UNITED STATES PATENT AND TRADEMARK OFFICE

APPLICATION NO.	FILING DATE	FIRST NAMED INVENTOR	ATTORNEY DOCKET NO.	CONFIRMATION NO.
10/626,361	07/23/2003	Jeremy A. Davis	200210054-1	1224
22879	7590	06/28/2006	EXAMINER	
HEWLETT PACKARD COMPANY P O BOX 272400, 3404 E. HARMONY ROAD INTELLECTUAL PROPERTY ADMINISTRATION FORT COLLINS, CO 80527-2400			RODRIGUEZ, WILLIAM H	
			ART UNIT	PAPER NUMBER
			3746

FINAL REJECTION

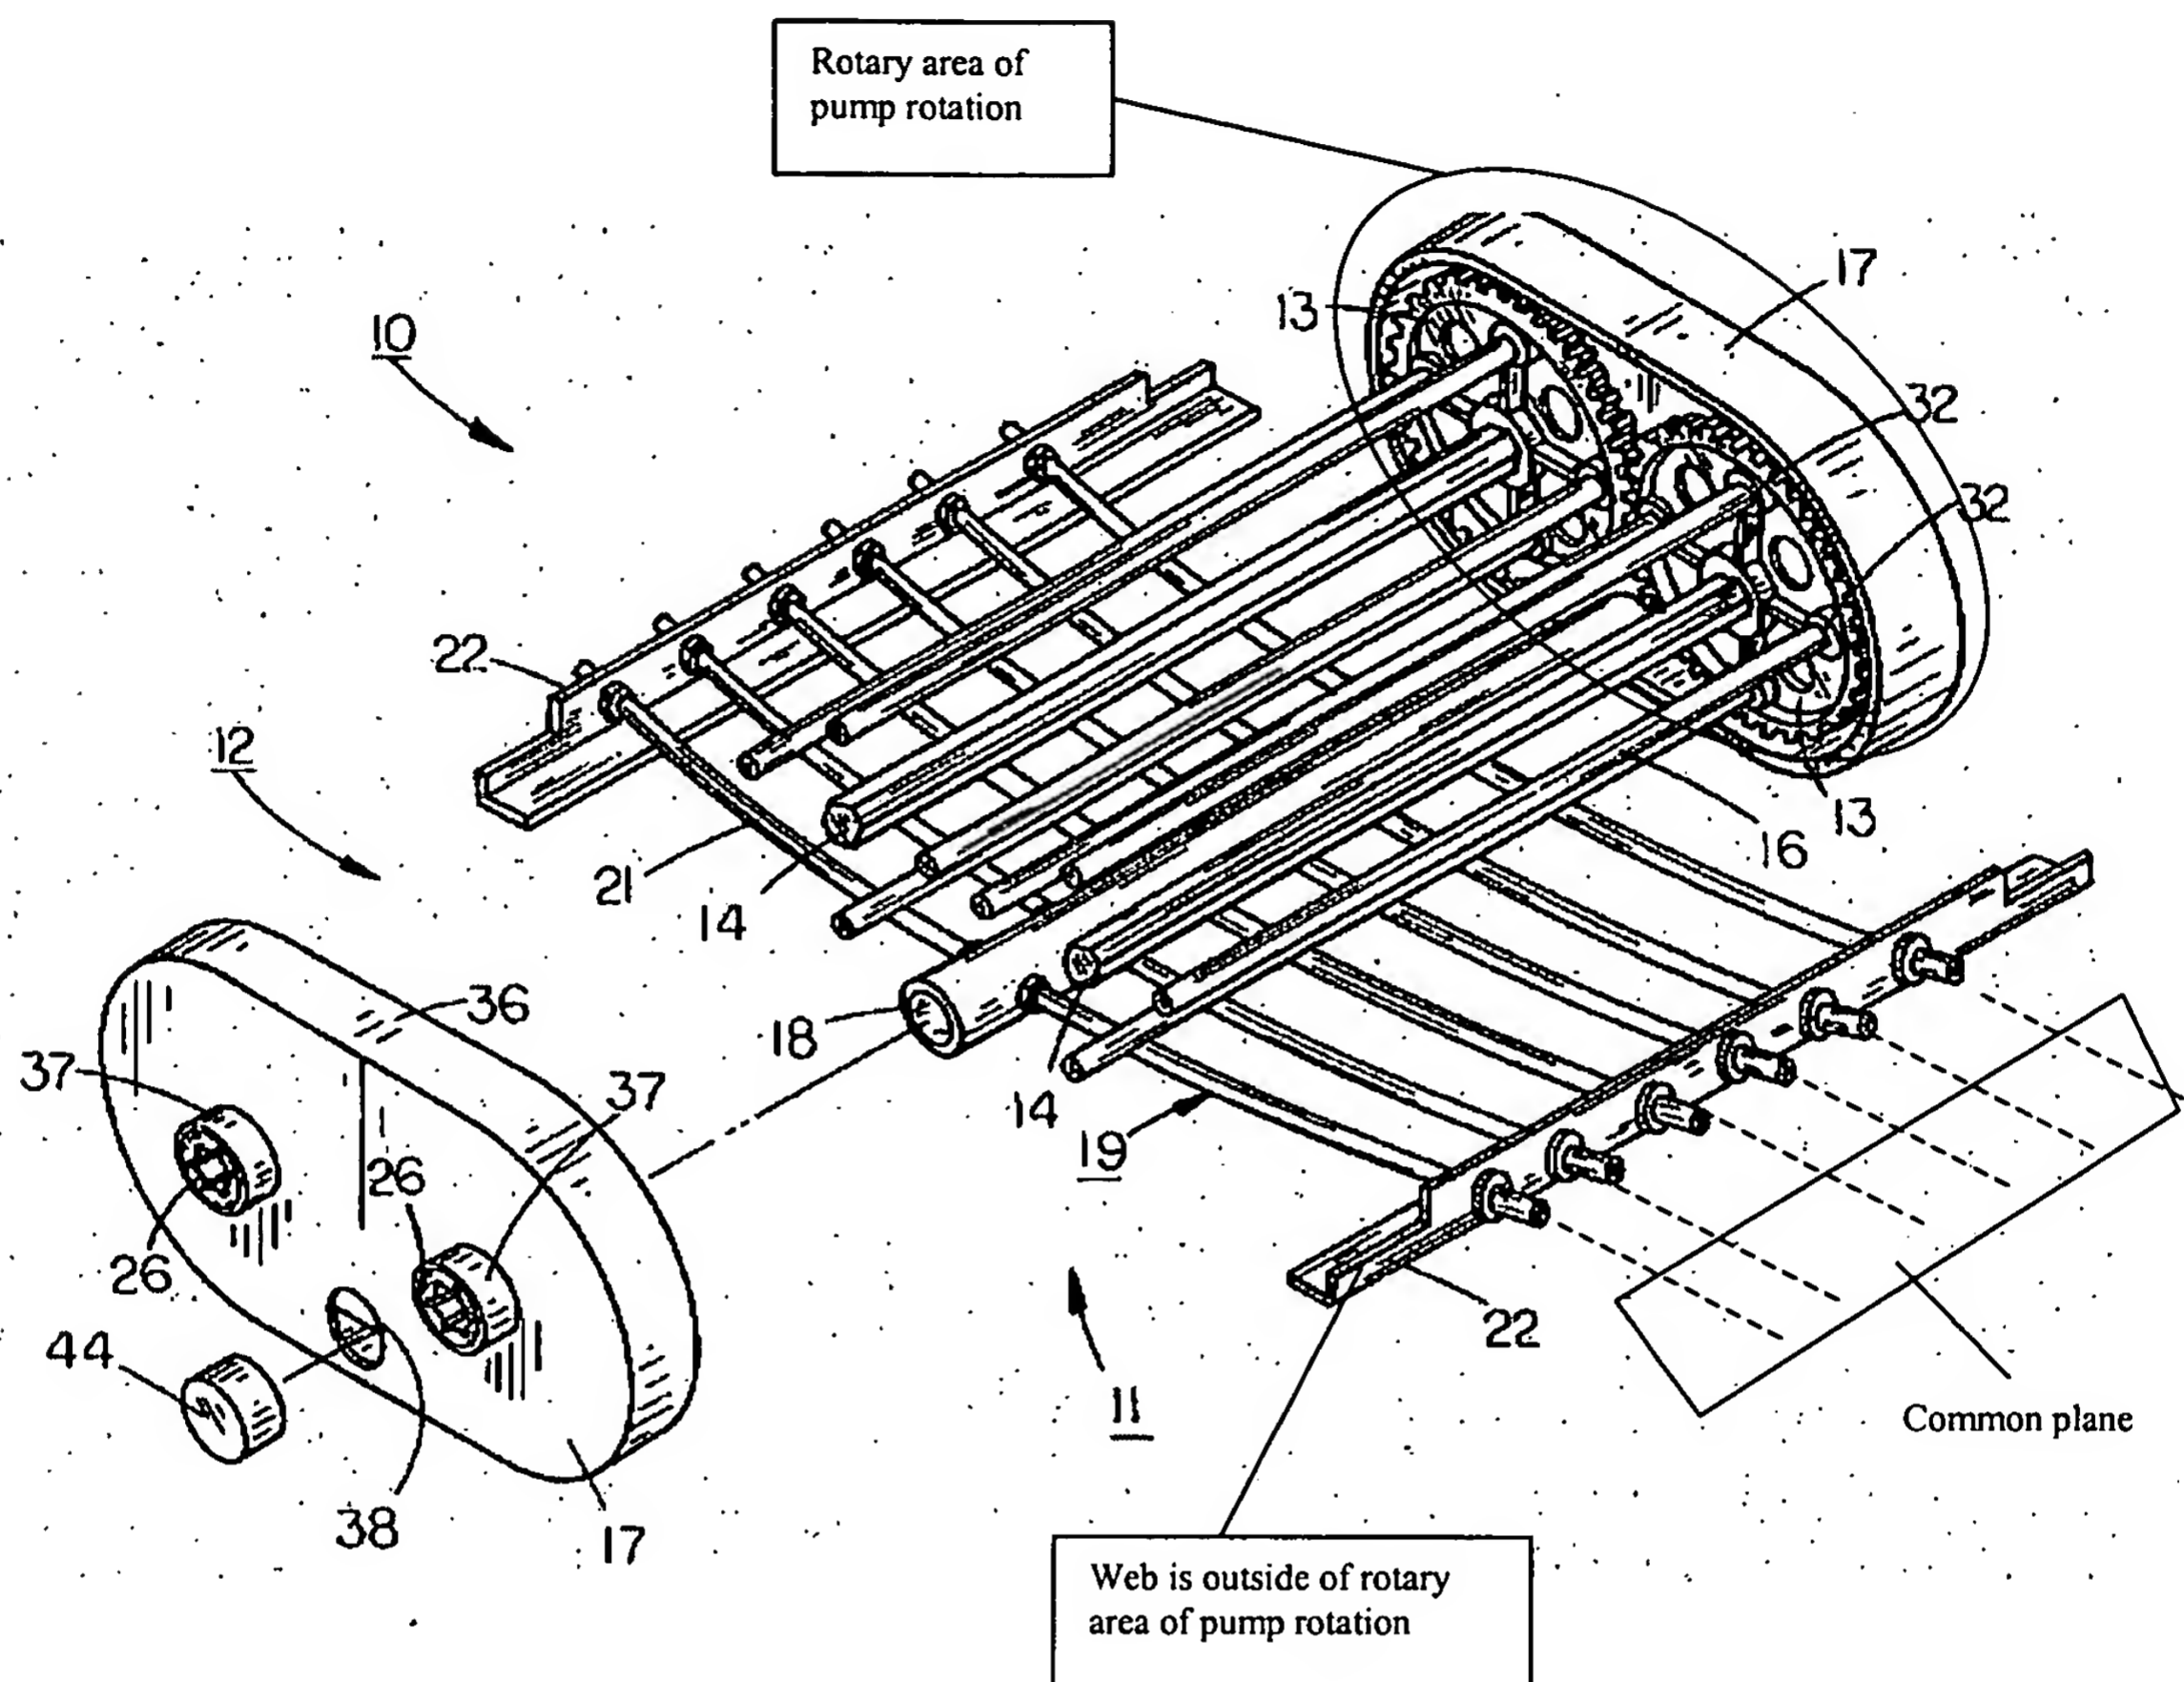
With respect to claims 1 and 19, **Schartz** teaches a pump having a rotary portion 16 which compels the movement of a fluid by peristaltic compression of resilient tubing 19 containing the fluid, a tube component comprising a plurality of adjacent resilient tubes; a web 22 interconnecting the adjacent resilient tubes, the resilient tubes has a cross-sectional centerline occurring in a common plane, and the web interconnects the resilient tubes in an area outside of the common plane, the rotary portion of the pump includes a rotary area of pump operation, and the web is outside the rotary area of pump operation. See particularly Figure above.

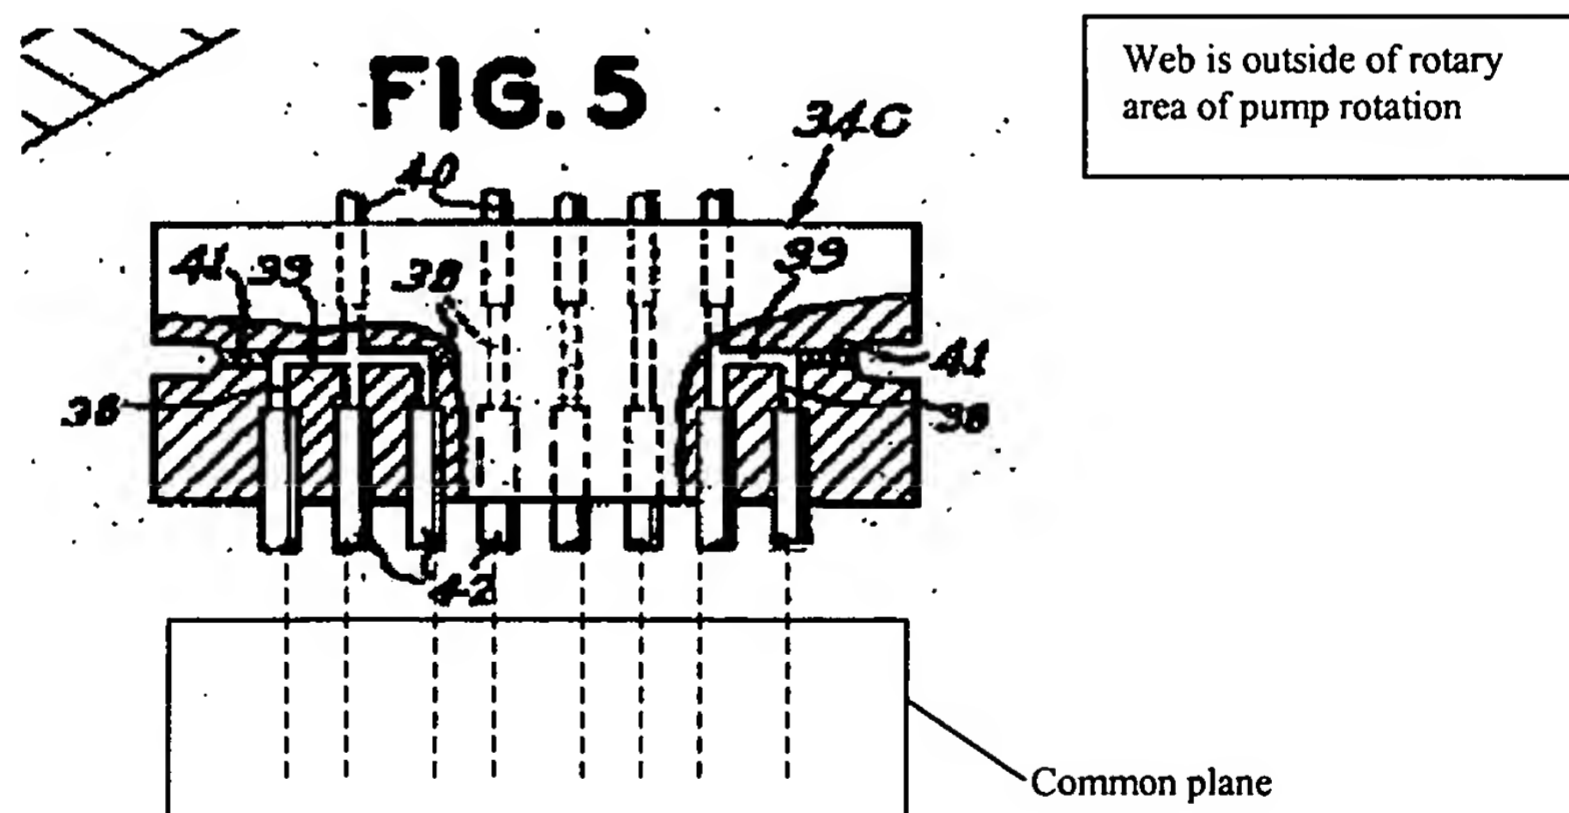
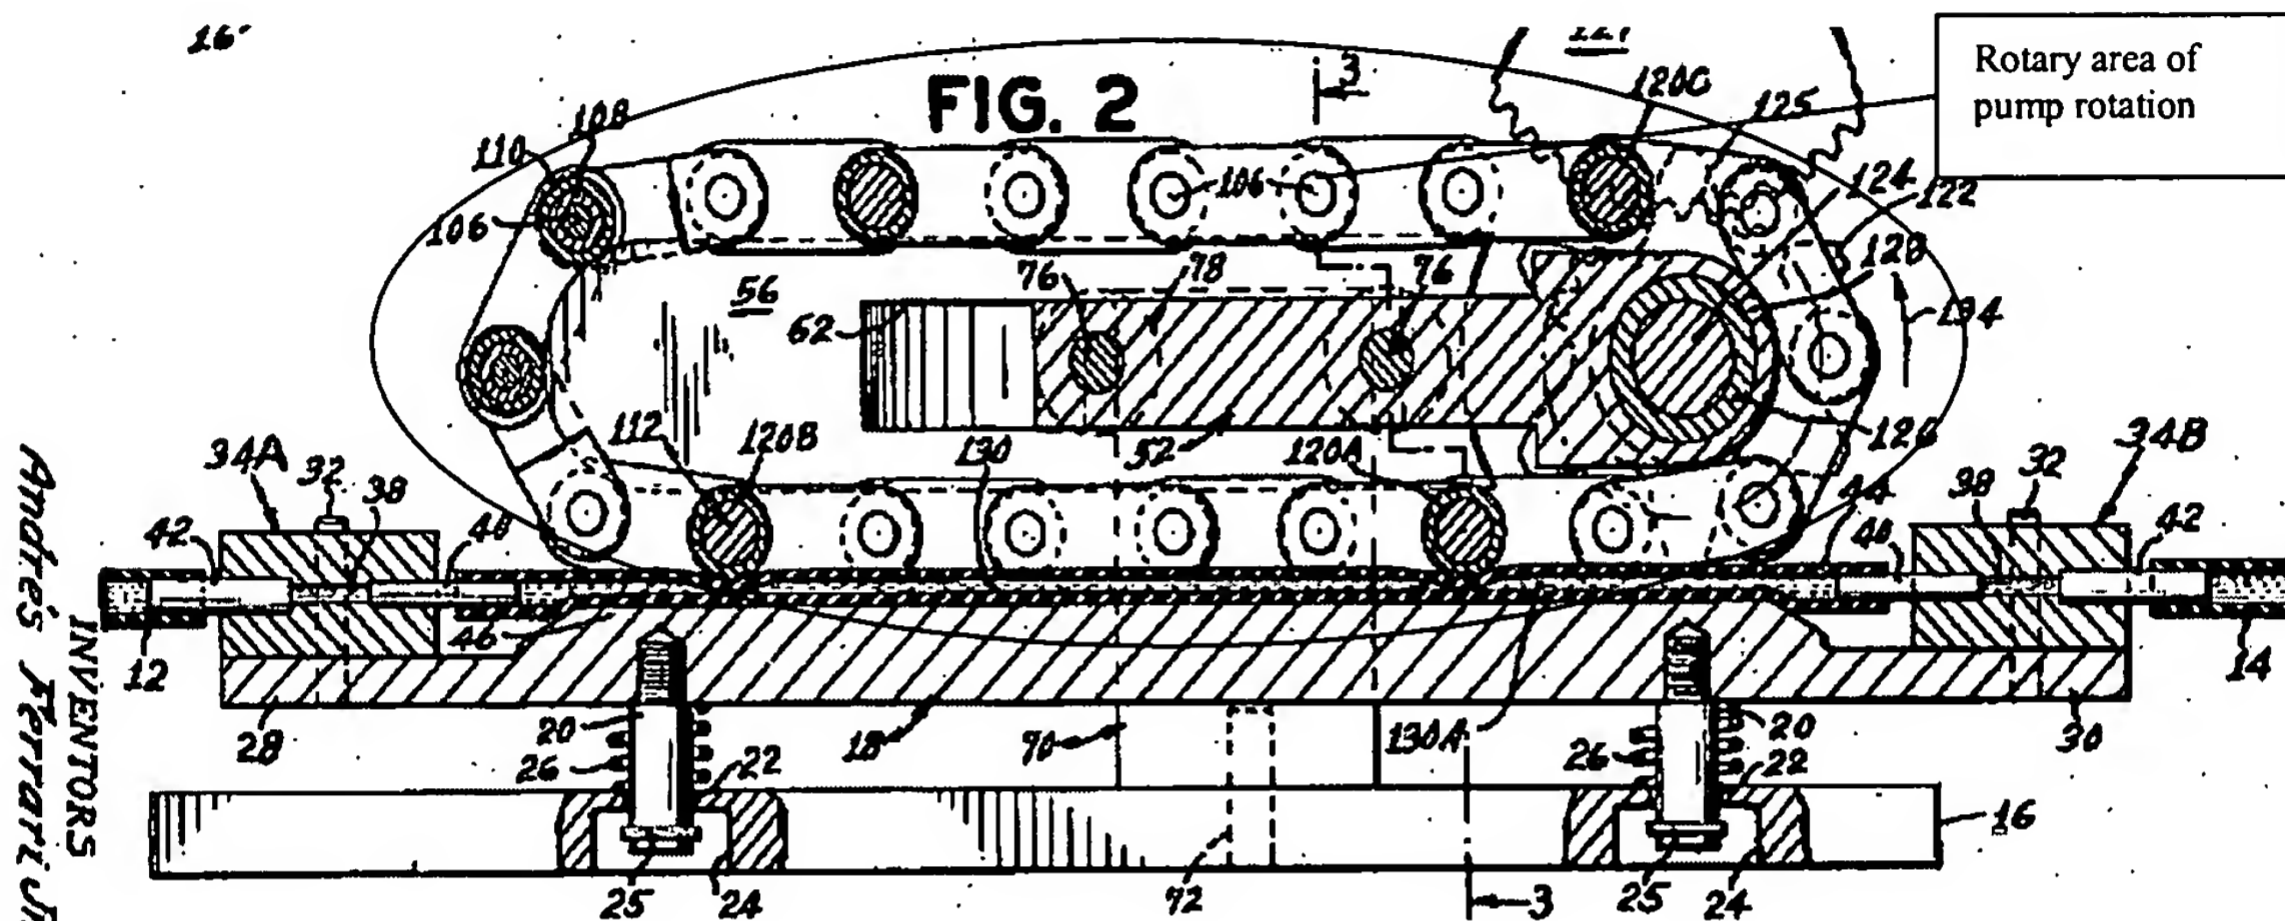
With respect to claim 1, **Ferrari** teaches a pump having a rotary portion 120 which compels the movement of a fluid by peristaltic compression of resilient tubing (44, 40, 42) containing the fluid, a tube component comprising a plurality of adjacent resilient tubes; a web 34C interconnecting the adjacent resilient tubes, the resilient tubes has a cross-sectional centerline occurring in a common plane, and the web interconnects the resilient tubes in an area outside of the common plane; the rotary portion of the pump includes a rotary area of pump operation, and the web is outside the rotary area of pump operation. See particularly **Figures 2, 5** above and column 4 lines 59-71 of **Ferrari**.

With respect to claim 13, **Ferrari** teaches a method of assembling a pump having a rotary portion 120 which compels the movement of a fluid by peristaltic compression of resilient tubing (40, 42, 44) containing the fluid comprising the following: providing a plurality of adjacent resilient tubes, and interconnecting the adjacent resilient tubes with a web 34C, providing a plurality of adjacent resilient tubes comprises providing each of the resilient tubes with a cross-sectional centerline occurring in a common plane, and interconnecting the adjacent resilient tubes with a web comprises interconnecting the resilient tubes in an area outside of the common plane, the rotary portion of the pump includes a rotary area of pump operation, and interconnecting the adjacent resilient tubes with a web comprises interconnecting the resilient

tubes in an area outside the rotary area of pump operation. See particularly **Figures 2, 5** above and column 4 lines 59-71 of Ferrari.
